**SUBJECT:** Responses to Request for Additional Information (RAI) Concerning  
Decommissioning Plan for the Ward Center for Nuclear Studies at Cornell University, TRIGA  
Reactor, Docket No 50-157, License R-80 and the ZPR, Docket No. 50-97, License R-89

**Attachment A: Responses to Request for Additional  
Information (RAI), Cornell University Research  
Reactors, Docket No. 0-157/97**

Figure 2-4 Ward Center Decommissioning Organization

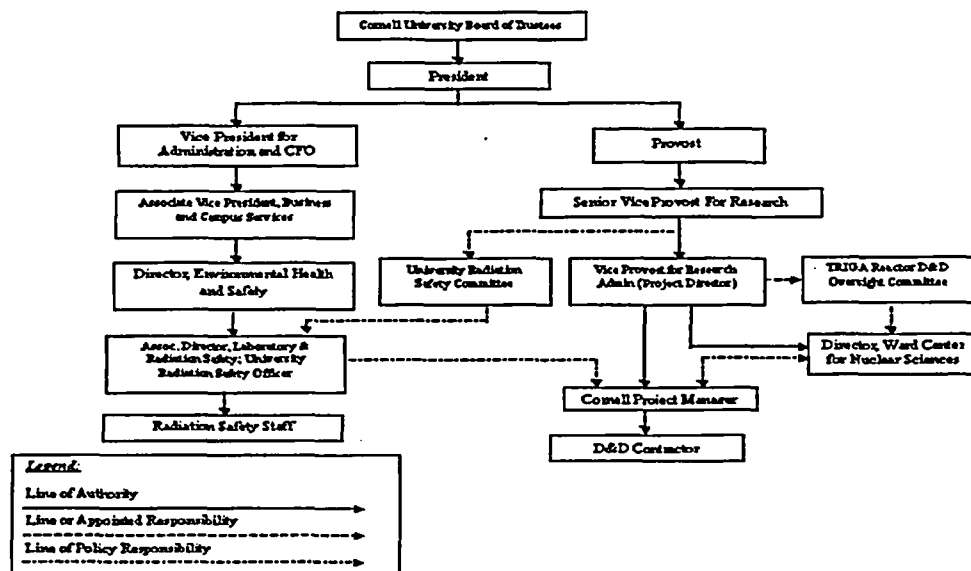
Please clarify how Ward Center Director for Nuclear Studies position and the Reactor Supervisor position fit in Figure 2-4.

*The Organizational Chart included in the original DP unintentionally left out the Director position. At the time that the DP was produced in the Summer of 2003, it was envisioned that the Director would perform many of the tasks now delegated and assigned to the Cornell Project Manager. Due to the current operational status of the facility, the Reactor Supervisor is no longer a separate entity. The Supervisor functions have all been delegated to the Ward Center Director.*

*Figure 2.4 was replaced and Section 2.4.2 was revised to read as follows:*

*Figure 2-4 was revised to identify this role. In addition, the Table of Contents has been revised to reflect the changed paragraph headers for paragraphs 2.4.2 and 2.4.3, reflecting these revised titles and personnel descriptions.*
